# Little Thompson River Hydrologic Analysis

Prepared for  
Colorado Department of Transportation

August 2014

*Response to CDOT and CWCB Review Comments (April 2014)*

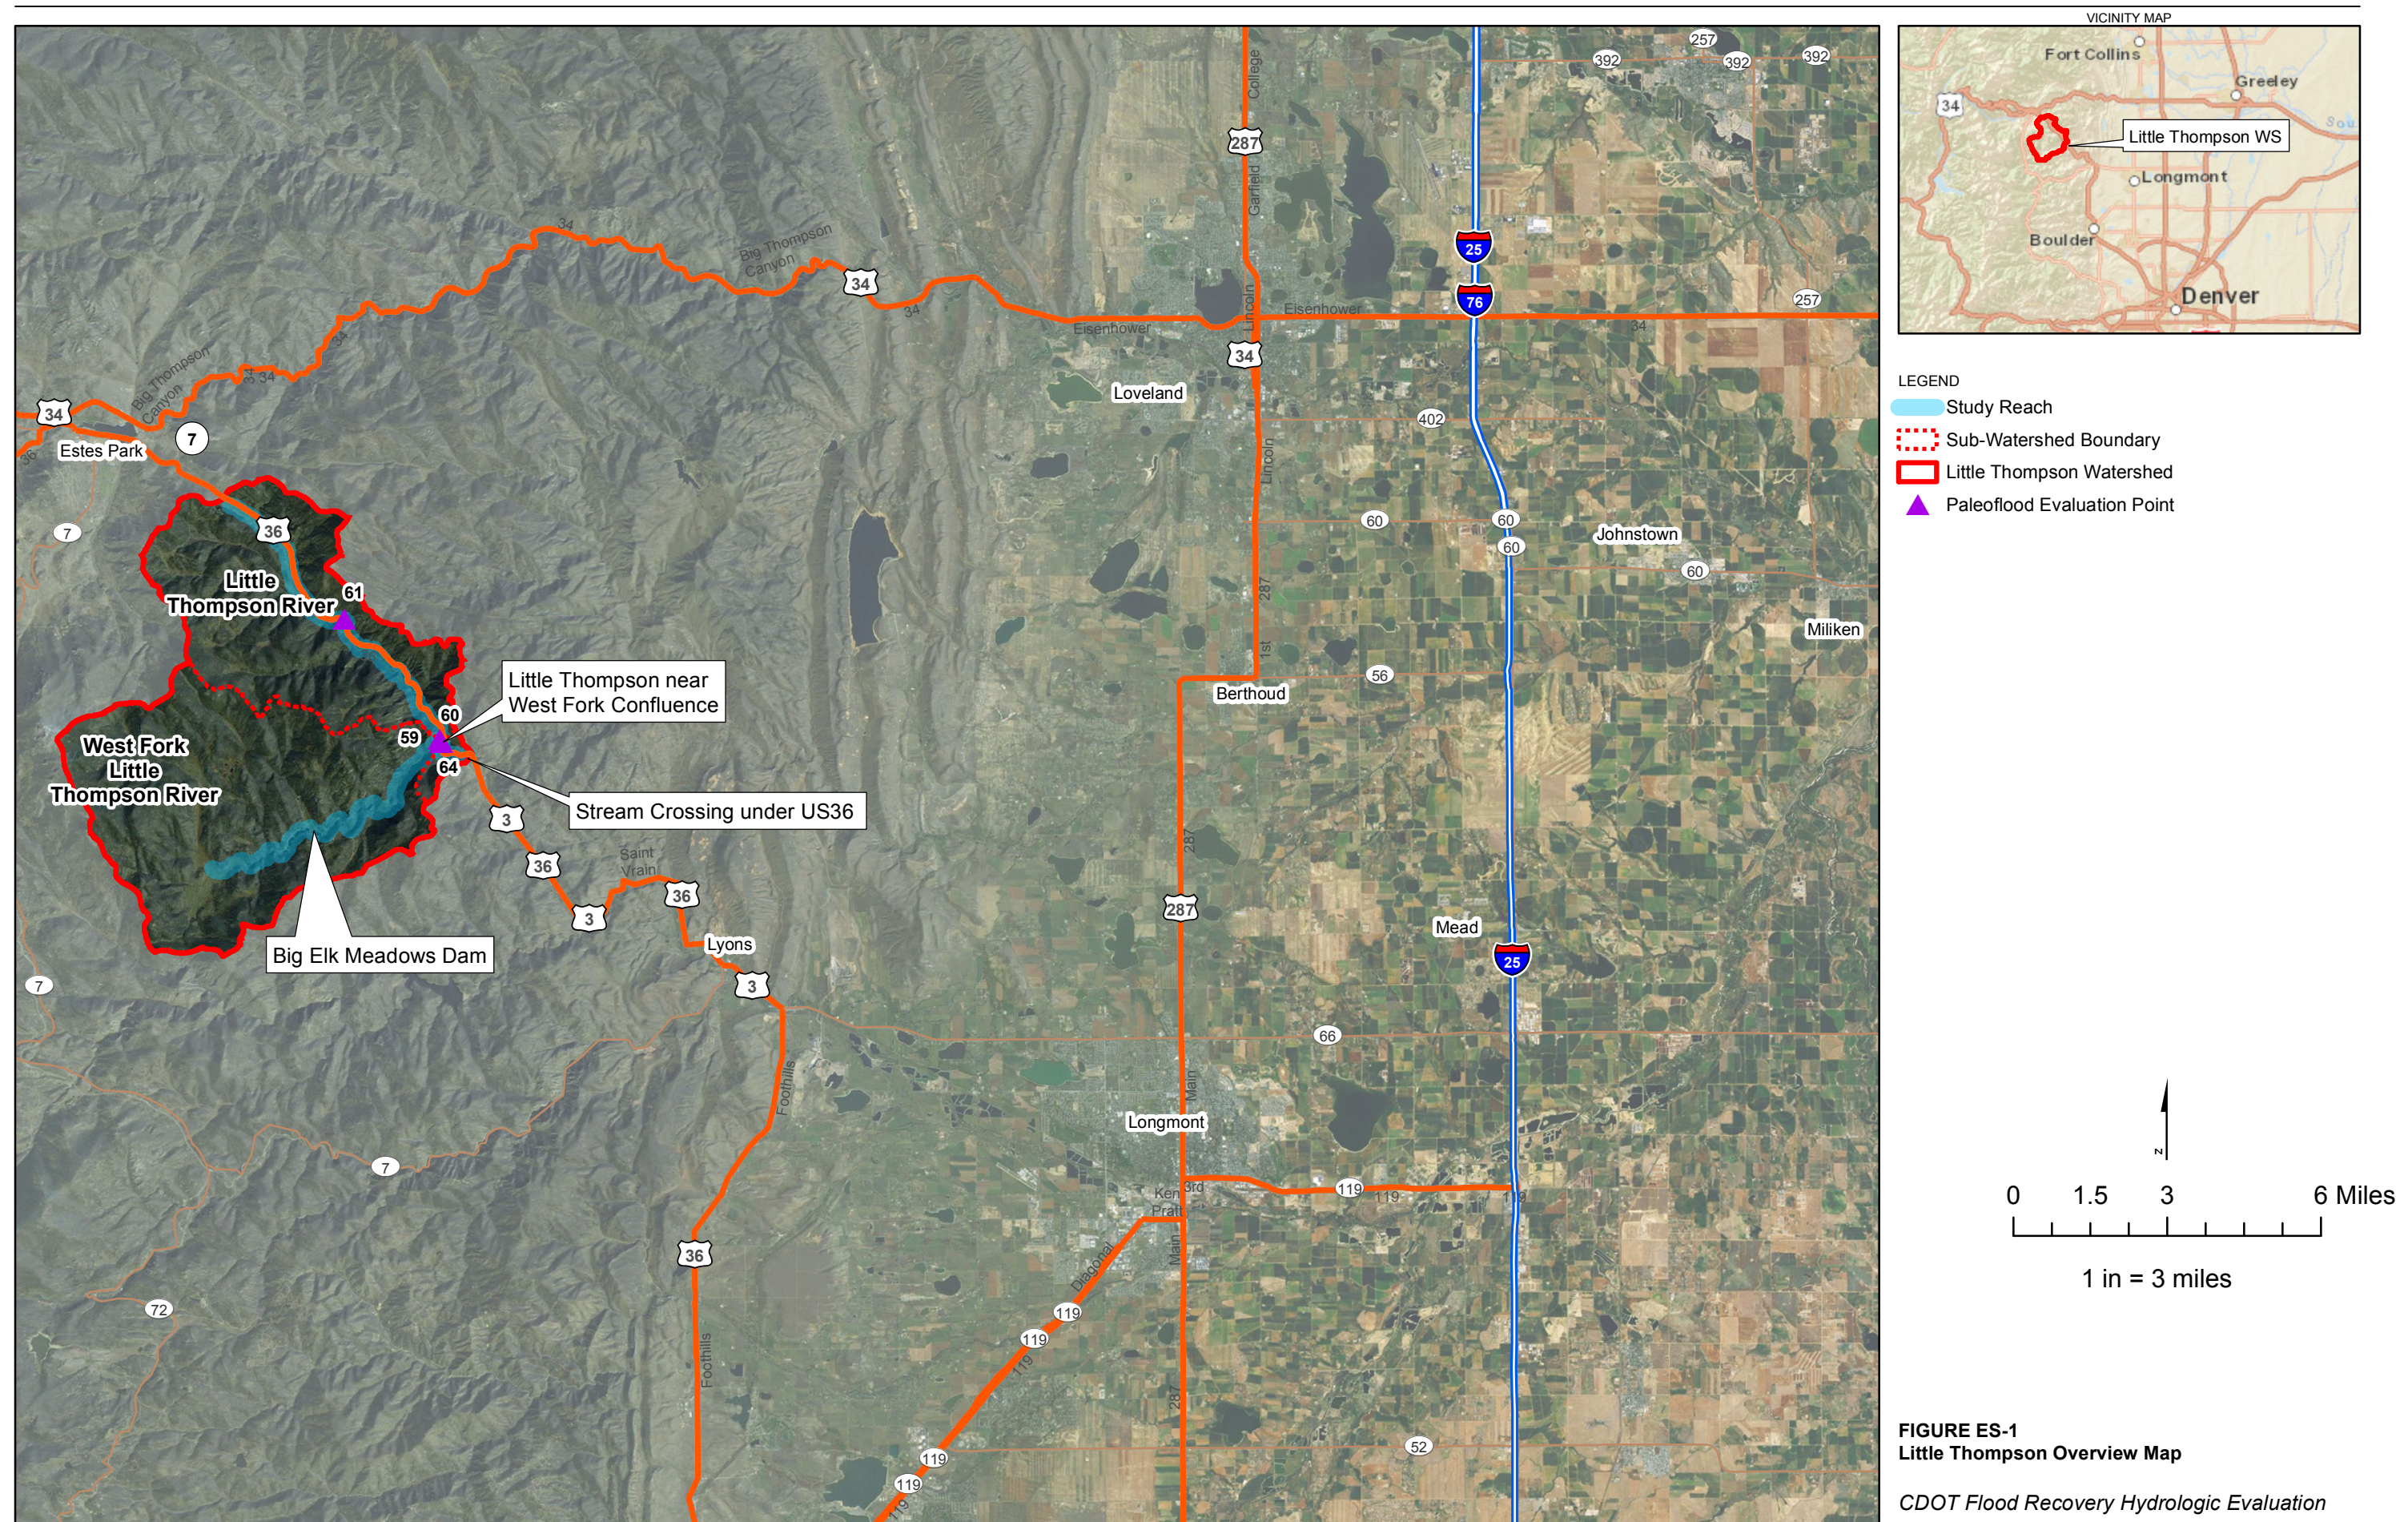
1. **Comment:** ES: Figure ES-1 is included in the Executive Summary, but I believe that the actual reference for it was missed. Providing that before referencing Table ES-1 may help the reader better understand where the discharge points in Table ES-1 are located.

**Response:** A reference to Figure ES-1 was added to the text before referencing Table ES-1.
2. **Comment:** Section 1.2: there is some discussion of the overall Little Thompson watershed, but the description refers only to the study area portion of the watershed. For example: the report states that the watershed is located in Larimer and Boulder County. In reality, it is also located in Weld County too. I would recommend some small changes to clarify whether it is referring to the entire watershed or only the study area. Along those same lines in the same section, it states that there are no regulatory flow rates published for the river. To clarify, that statement is true only for the study area portion of the river.

Figure B-10 - Little Thompson September 2013 Rainfall

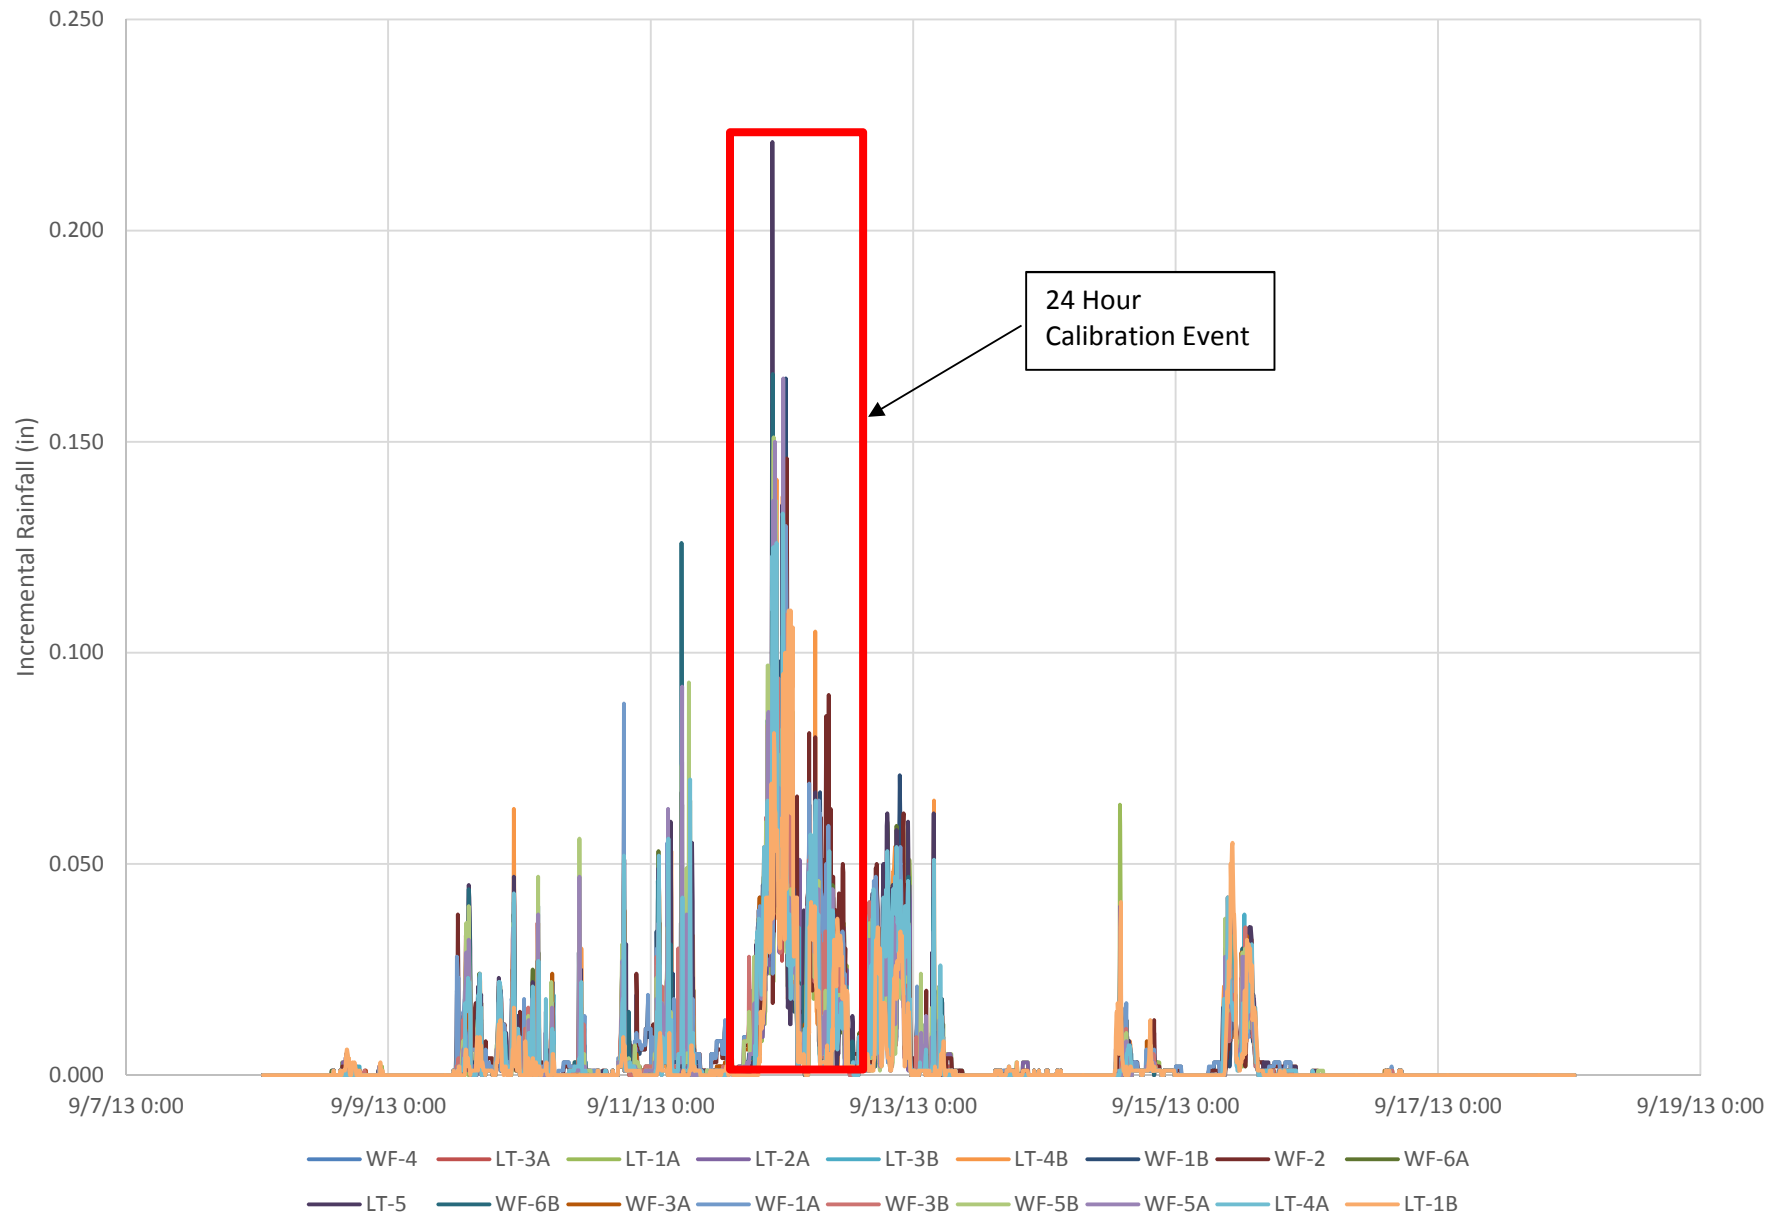
9. **Comment:** In **Section 2.4.2**, is it possible to create a graphic of the rainfall over the 7 days simultaneously illustrating the ebbs and peaks of the streamflows? That way the reader understands more clearly why the choices about 24-hours vs. 7-days were made in the development of the calibrated model.

5. **Comment:** In **Section 1.5.2**, is it possible to create a graphic of the rainfall over the 7 days simultaneously illustrating the ebbs and peaks of the streamflows? That way the reader understands more clearly why the choices about 24-hours vs. 7-days were made in the development of the calibrated model.

**Response:** A graphic was added to the Appendix to show the rainfall event.
10. **Comment:** In **Section 2.4.5 – Rainfall Inputs subsection**, it would be helpful to have graphics of the actual rainfall distribution over the entire time and the 24-hour rainfall used in the model for the various sub-basins. The basic questions are, *“How well, in terms of rainfall input throughout the watershed, does the model represent what actually happened in September 2013?”* and *“Should we be persuaded or not?”* -

**Response:** A graphic was added to the Appendix to show the rainfall event.
6. **Comment:** In **Section 2.4.2** the current final sentence reads, “*Therefore, this method was discarded in favor of calibration to the peak 24-hour event and use of the commonly accepted 24-hour design hyetograph.*” Having just read about how well the application of the peak 48-hour event worked, the reader is left wondering if the 24-hour event works well enough or not, or if it was used simply for convenience.

**Figure B-14 - 1 Percent Annual Chance Peak Unit Discharge vs. Subbasin Area**

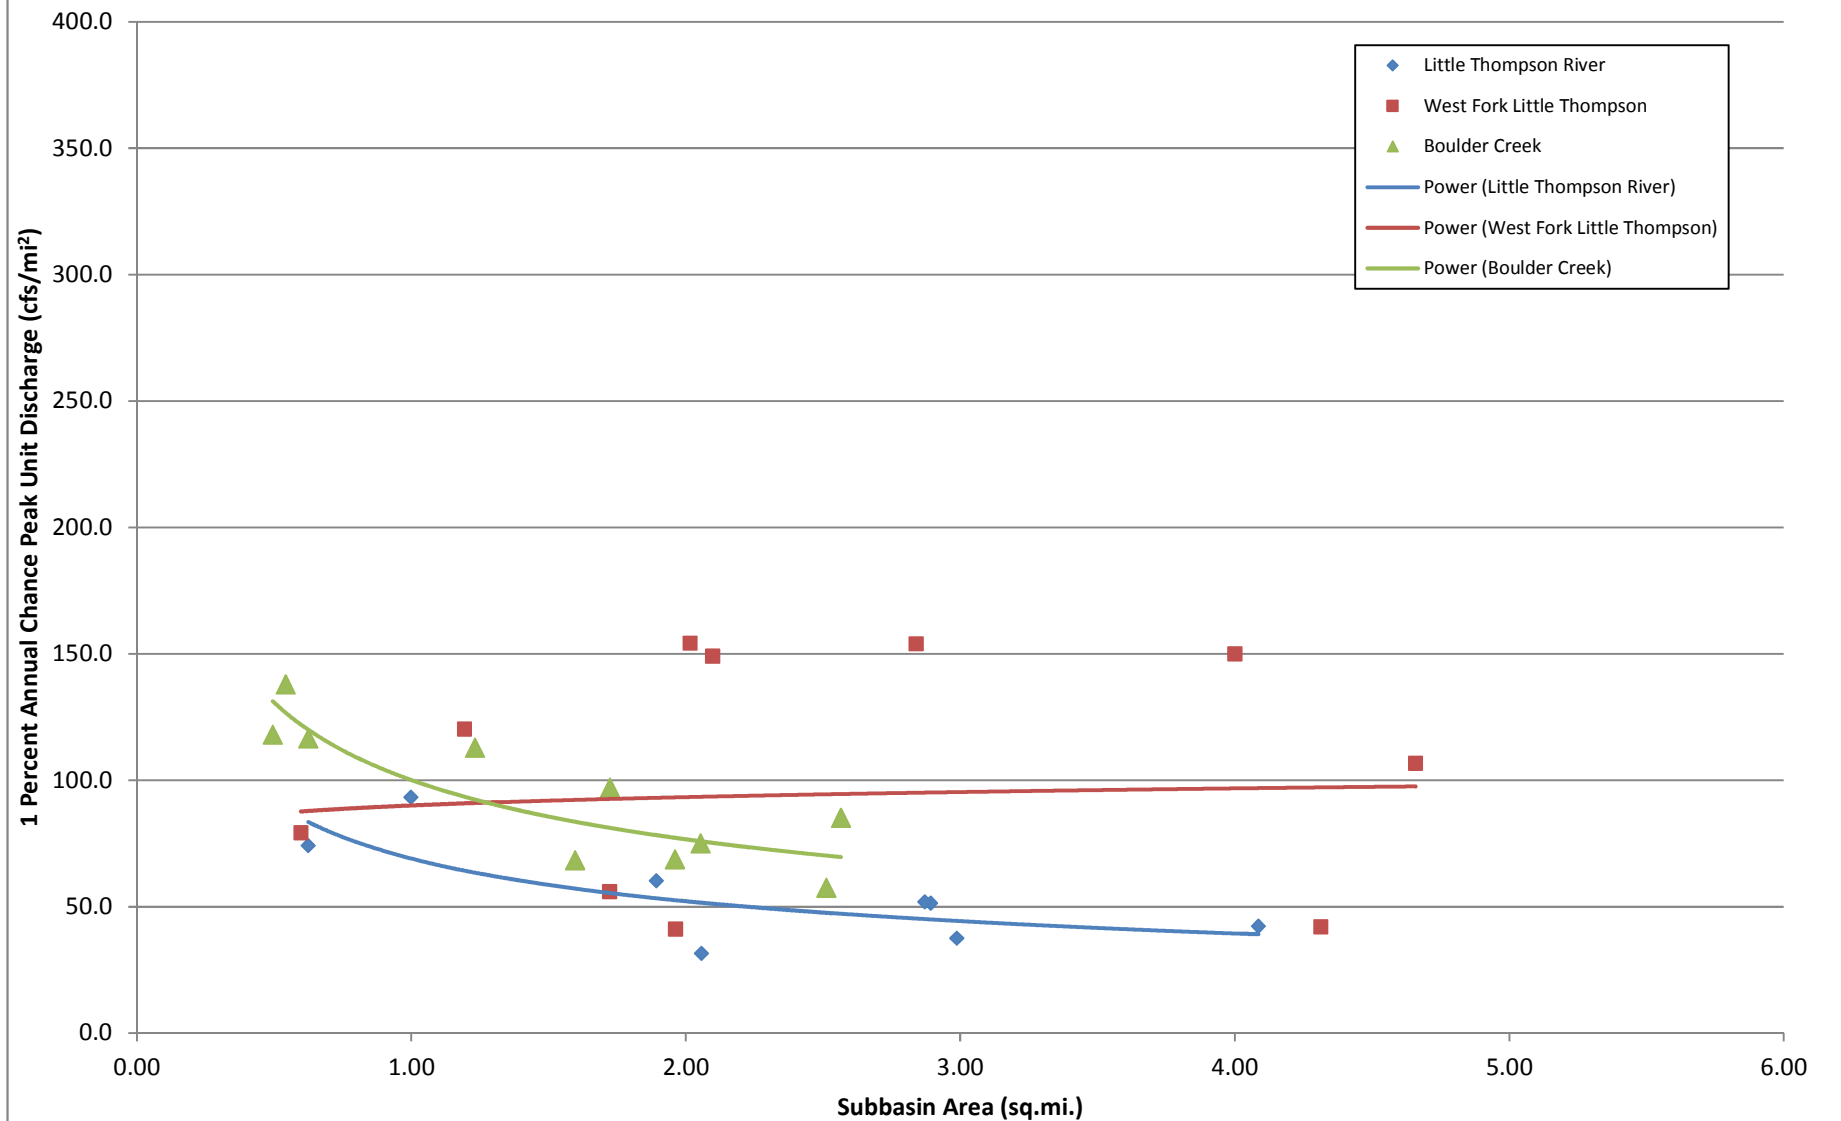
16. **Comment:** Determine if the 1-percent chance discharges for Little Thompson River are reasonable. The trend line through the 1-percent chance discharge is greater than 1 suggesting that the upstream 1-percent chance discharges may be too low relative to downstream areas.

6. **Comment:** Section 3.1 (Figure B-14): To provide comparison and additional validation of the results, it would be good to add data from similarly sized, nearby basins (assuming similar characteristics) that have measured streamflow data from which 1-percent peak flows have been computed (if the data exists).

**Response:** The trendline for Little Thompson included a point that is downstream of the confluence at drainage area 43 sq. miles. This point was omitted from the trendline and this figure was added to the appendix.

**Response:** The 1-percent peak flows per drainage area for Boulder Creek have been added to Figure B-14 for comparison. This report has been referenced for the reader. The values are in a similar range as Little Thompson River and West Fork Little Thompson River from approximately 25 to 150 cfs /square mile for subbasins sized from approximately 0.5 to 5 square miles.
